**Figure 3. Recall Kit 0190**

## Credit Procedure

**Figure 1.**

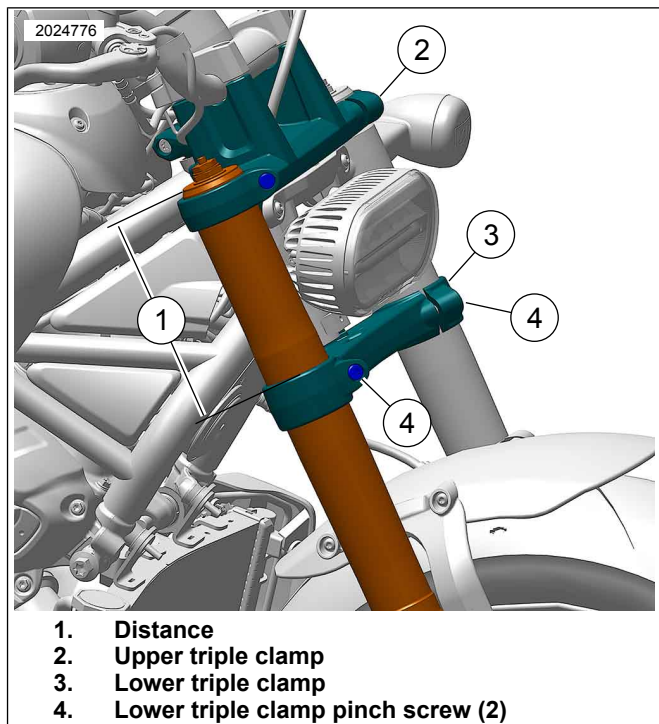
- e. Repeat procedure on opposite side.
- 3. If distance is within specification, adjust lower triple clamp pinch screws (4) to **new torque**:
  - a. Leave lower triple clamp (3) in its current location.
  - b. Loosen screws (4) individually 90 degrees.
  - c. Tighten screws (4).  
Torque: 33 N·m (24 ft-lbs)
- 4. See Figure 3. Install **new** upper triple clamp (3) from recall kit. See service manual.
  - a. See Figure 1. Use **new** screw (Part No. 10200925) supplied in recall kit for installation of fork lock to **new** upper triple tree.
